## HOLDOVER

*Revised*

### RIVERWOOD SUBDIVISION

# DETAIL SITE PLAN

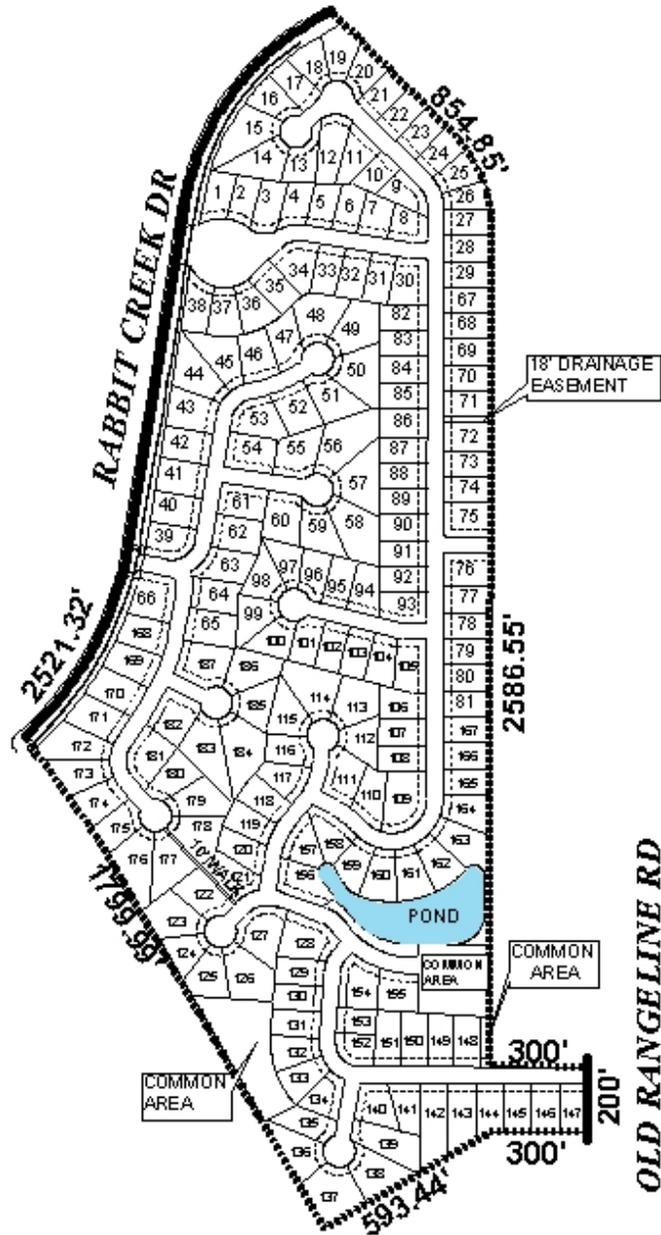
While the general configuration and lot sizes appear to comply with the Subdivision Regulations, there are several other points of concern that should be addressed. The plat illustrates several areas that are either not identified or are identified as a sidewalk path. These areas must be accounted for, identified and appropriately labeled. Also, a note should be placed on the plat indicated that maintenance of these areas shall be the responsibility of the property owners.

Also, the plat does not reflect the required minimum building setback line.

*Conditions placed on the previous approvals (Phases I & II) would still be applicable, and should be included as conditions of the approval of this new request. Those conditions include the provision of traffic calming devices, identification of all common areas (as also discussed above), the provision of buffers and the provision of the required 25' building setback line.*

*Based on the preceding, the revised plat for 187 lots meets the minimum requirements of the Subdivision Regulations and is recommended for Tentative Approval subject to the following conditions: 1) the provision of traffic calming devices, exact number, location and design to be approved by County Engineering; 2) all unidentified areas and areas for "public" use be identified as Common Area; 3) placement of a note on the final plat stating that maintenance of all common areas shall be the responsibility of the property owners association; 4) placement of a note on the final plat stating that there shall be no curb cuts to Rabbit Creek Drive; and 5) placement of a note on the final plat stating that buffers in compliance with Section V.A.7 should be provided if any lots are developed commercially and abut residentially developed properties.*
